# **Groundwater Application Review Summary Form**

Application # G- 18795 GW Reviewer Gabriela Ferreira, Ben Scandella Date Review Completed: 3/15/2025 Note: this re-review addresses the finding in section B1a in accordance with the 1/18/2023 clarification memo on the current policy for determining over-appropriation for new groundwater applications. No other modifications from the 3/31/2020 review originally completed by Ben Scandella were made. **Summary of GW Availability and Injury Review:** Groundwater for the proposed use is either over appropriated, will not likely be available in the amounts requested without injury to prior water rights, OR will not likely be available within the capacity of the groundwater resource per Section B of the attached review form. **Summary of Potential for Substantial Interference Review:** There is the potential for substantial interference per Section C of the attached review form. **Summary of Well Construction Assessment:** ☐ The well does not appear to meet current well construction standards per Section D of the attached review form. Route through Well Construction and Compliance Section.

# PUBLIC INTEREST REVIEW FOR GROUNDWATER APPLICAT

## **Stream Depletion Modeling Results:**

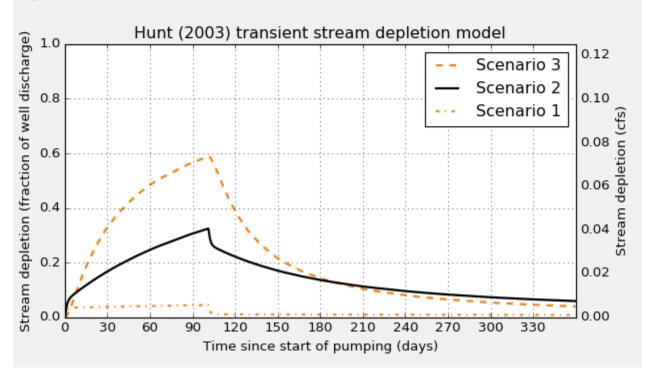
**Comments:** Using the Hunt, (2003) model and parameters appropriate for the hydrogeologic setting (Freeze and Cherry, 1979), streamflow depletion at 30 days is estimated to be likely less than 25% (see model parameters and results below).
